# HISTORIC AND DESIGN REVIEW COMMISSION

**HDRC CASE NO:** 2020-122  
**ADDRESS:** 533 E CARSON  
**LEGAL DESCRIPTION:** NCB 993 BLK 3 LOT S 96.91 FT 7 (ARB 7C)  
**ZONING:** MF-33, H  
**CITY COUNCIL DIST.:** 2  
**DISTRICT:** Government Hill Historic District  
**APPLICANT:** Mary Jo Vargas/VARGAS MARY JOSEPHINE  
**OWNER:** Mary Jo Vargas/VARGAS MARY JOSEPHINE  
**TYPE OF WORK:** Siding and window replacement  
**APPLICATION RECEIVED:** March 04, 2020  
**60-DAY REVIEW:** May 03, 2020  
**CASE MANAGER:** Huy Pham

## REQUEST:

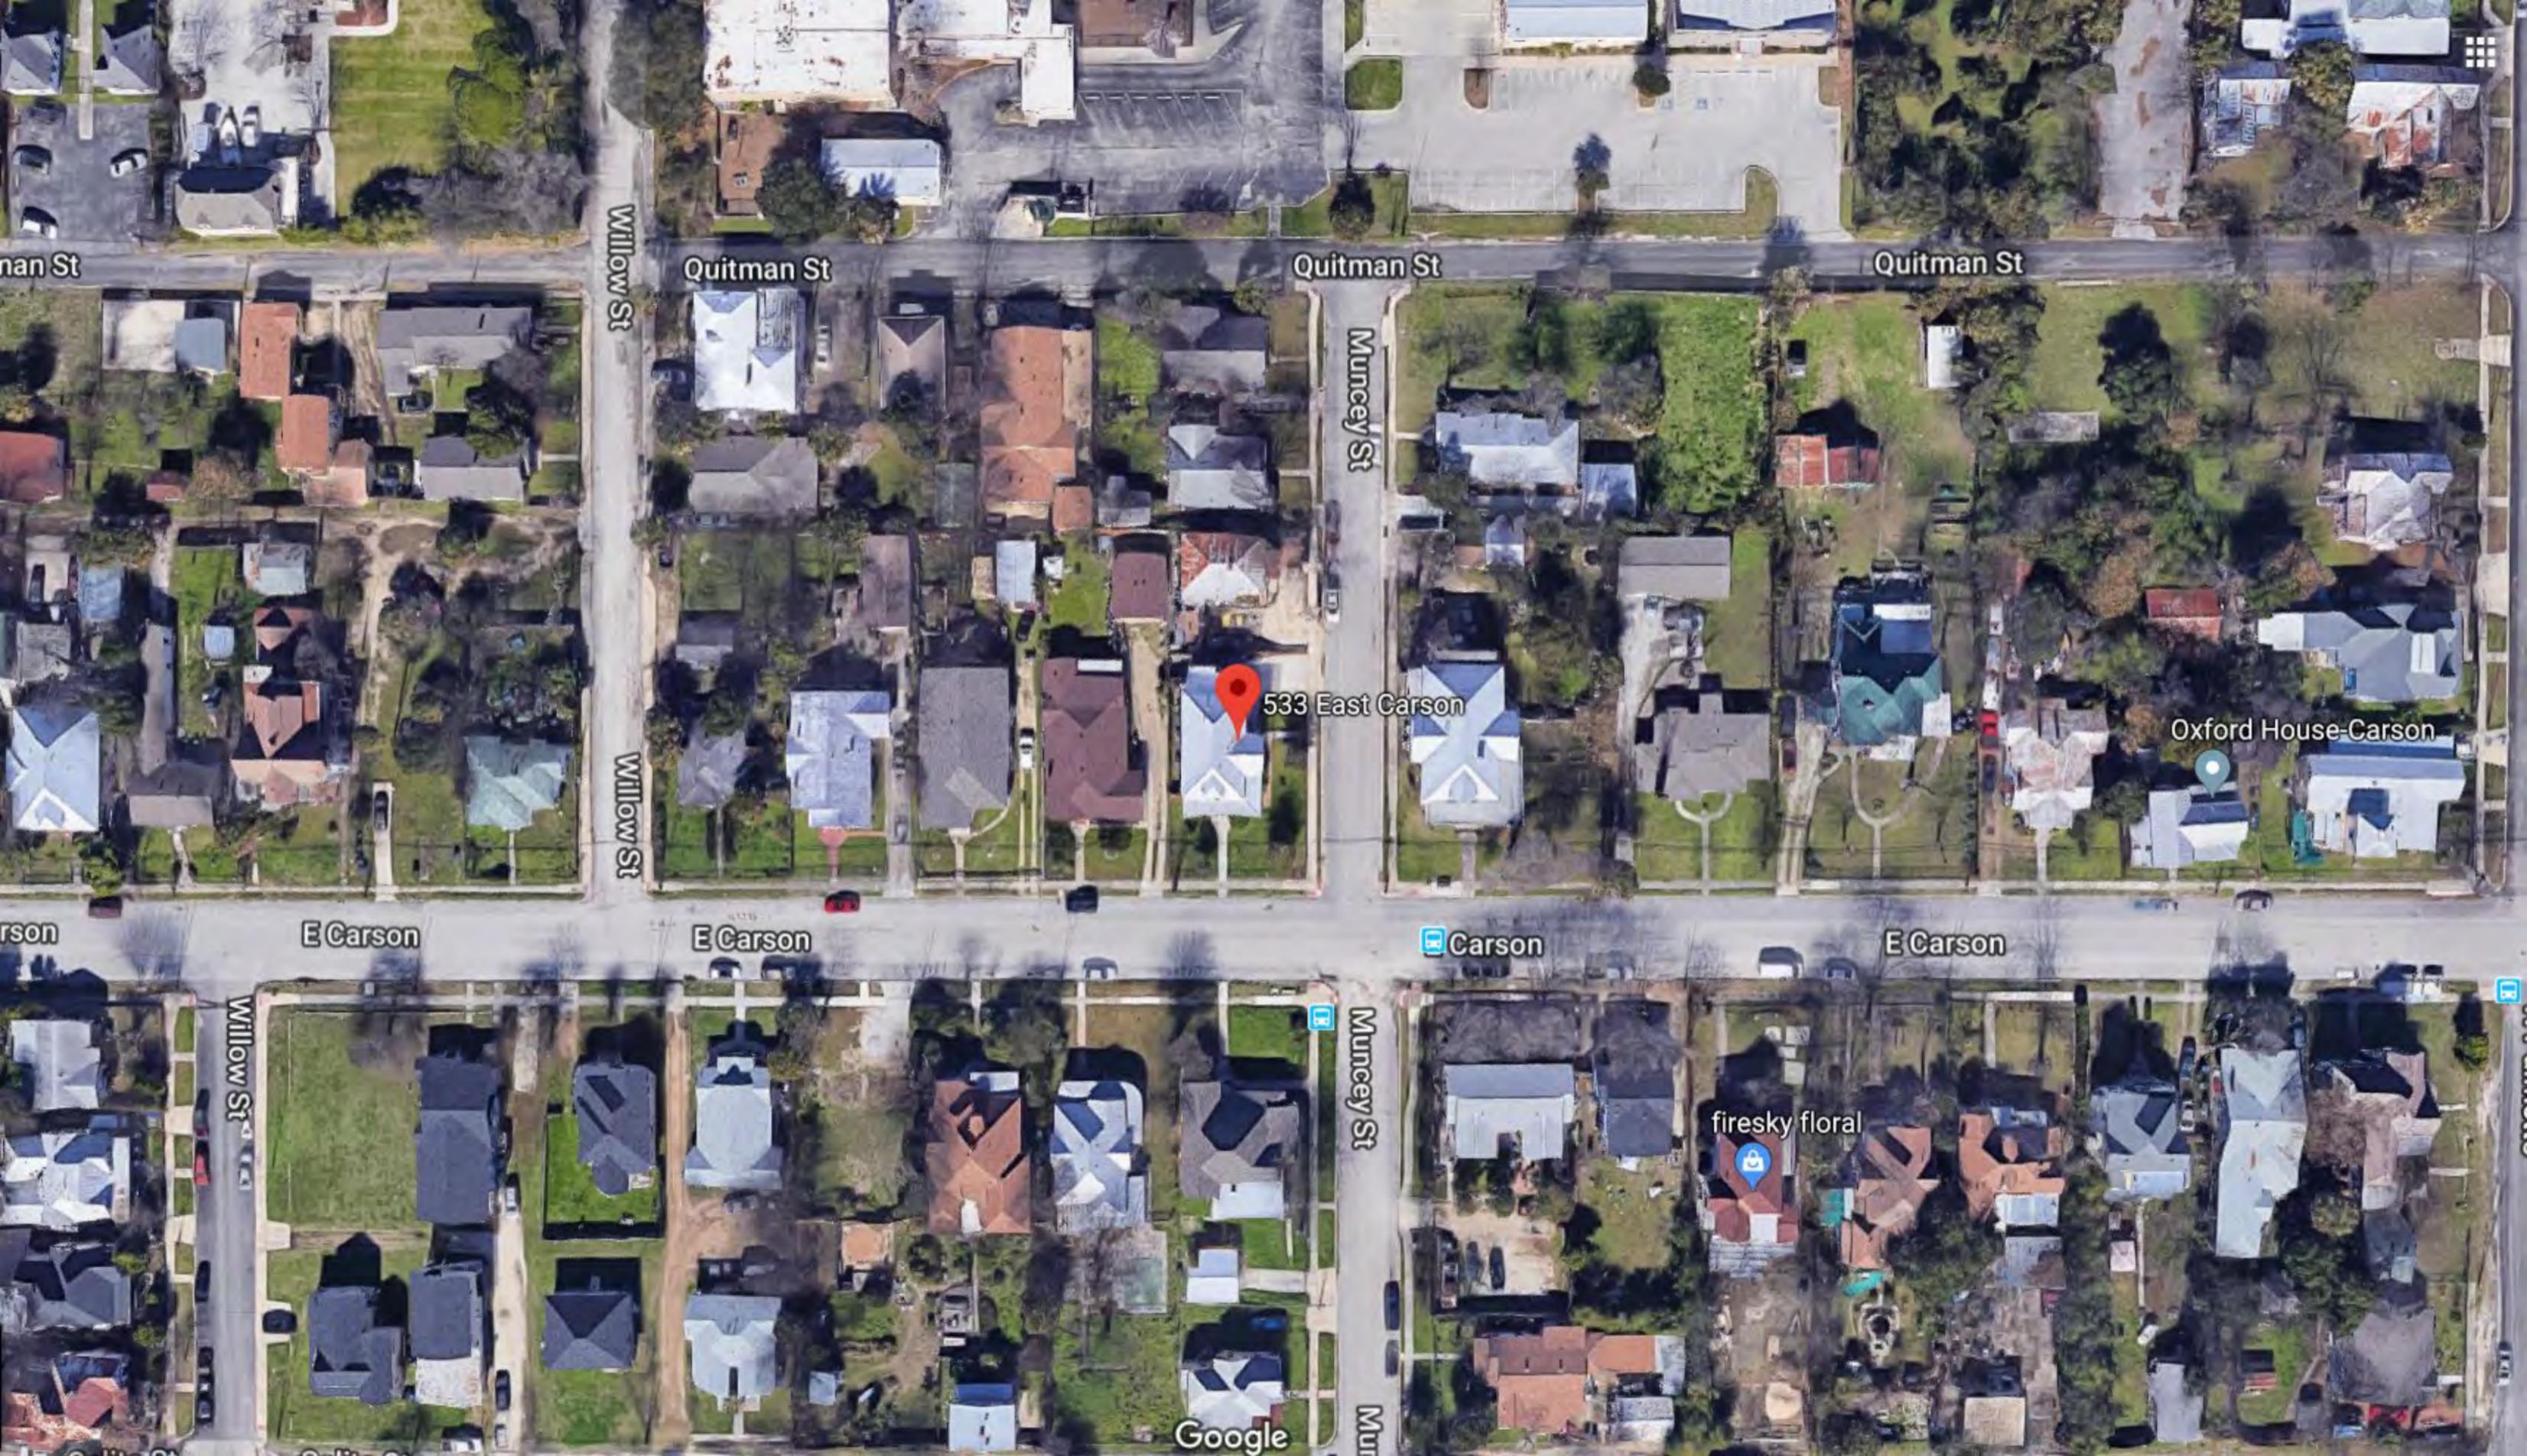
Staff does not recommend approval of items 1, 2, and 3 based on finding c. All existing wood siding should be restored in place, and any completely missing or fire damaged areas should feature wood lap siding that matches the historic profile.

Staff does not recommend approval of item 4. window replacement on the porch enclosure and rear addition. The wood windows are found to be repairable. All window repair and replacement must adhere to *Standard Specifications for Original Wood Window Replacement*.

Staff recommends approval of item 5. installing a new wood window where the original window is completely missing after fire damage. All window repair and replacement must adhere to *Standard Specifications for Original Wood Window Replacement*.
